Interactive comment on “Decomposition analysis of water footprint changes in a water-limited river basin: a case study of the Haihe River Basin, China” by Y. Zhi et al.

Received and published: 18 March 2014

Response to Reviewer 2

Fig. 1. Location of study area (adapted from website of Haihe River Water Conservancy Commission <http://www.hwcc.gov.cn/pub/hwcc/static/szygb/gongbao2011/>)

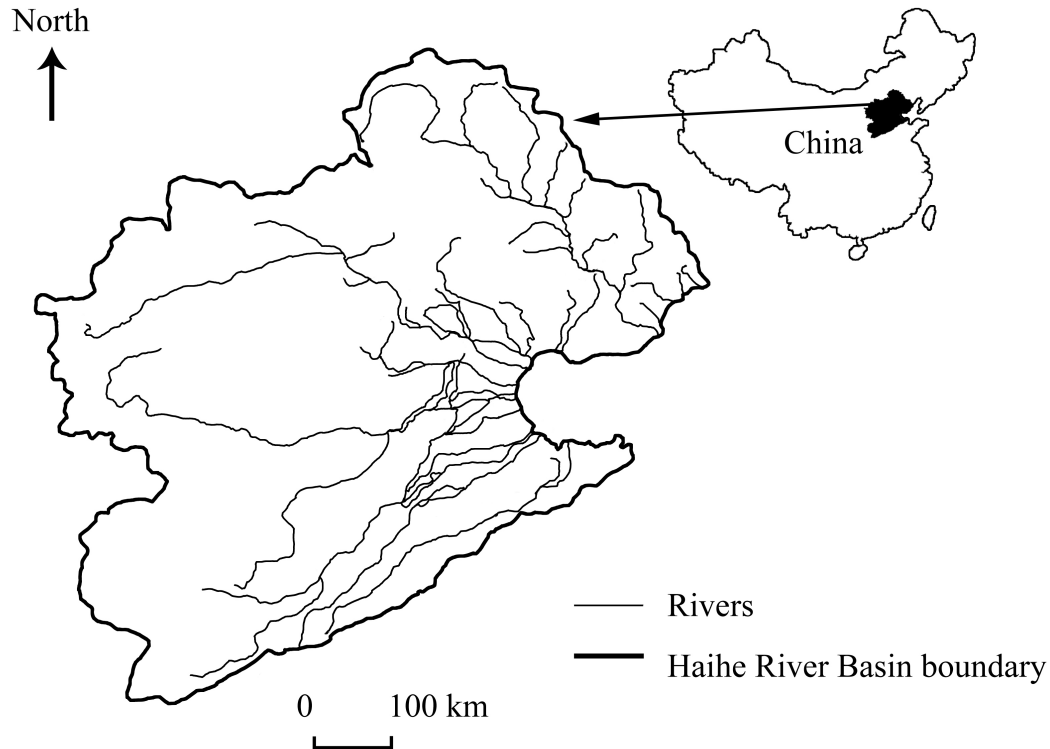
4 The title of 2.1 should be changed as Study area, and a location map should be supplemented in this part; Response: Following this comment, we have changed the title of 2.1 to “Study area” (see page 4, line 21). We have also added the location map as follows, which was adapted from website of Haihe River Water Conservancy.

Fig. 2. Figure 2a. WFs in the HRB in 2002

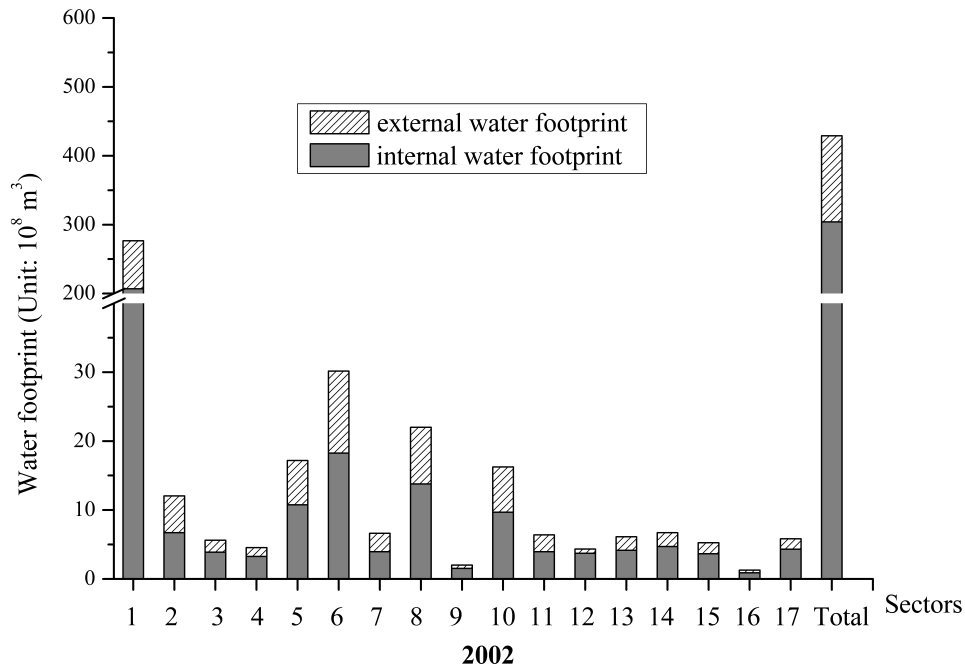
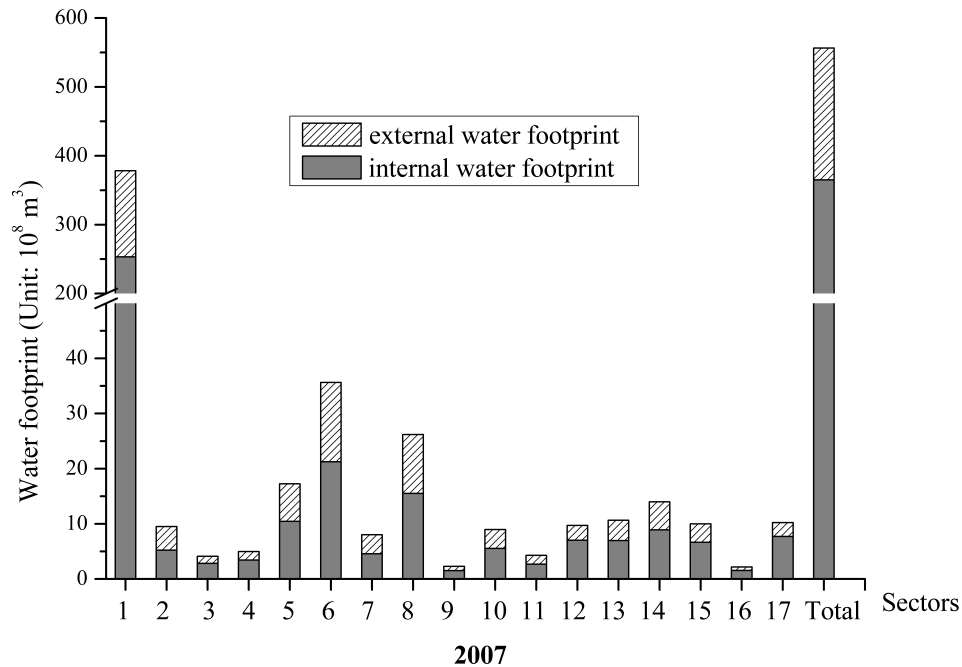
9 The name of X-axis and Y-axis in Fig.1 should be marked. Response: The names of X-axis and Y-axis in Fig.1 (Fig. 2 in the revised version) were added. X-axis meant the number of sectors, and Y-axis meant their water footprints (108 m3).
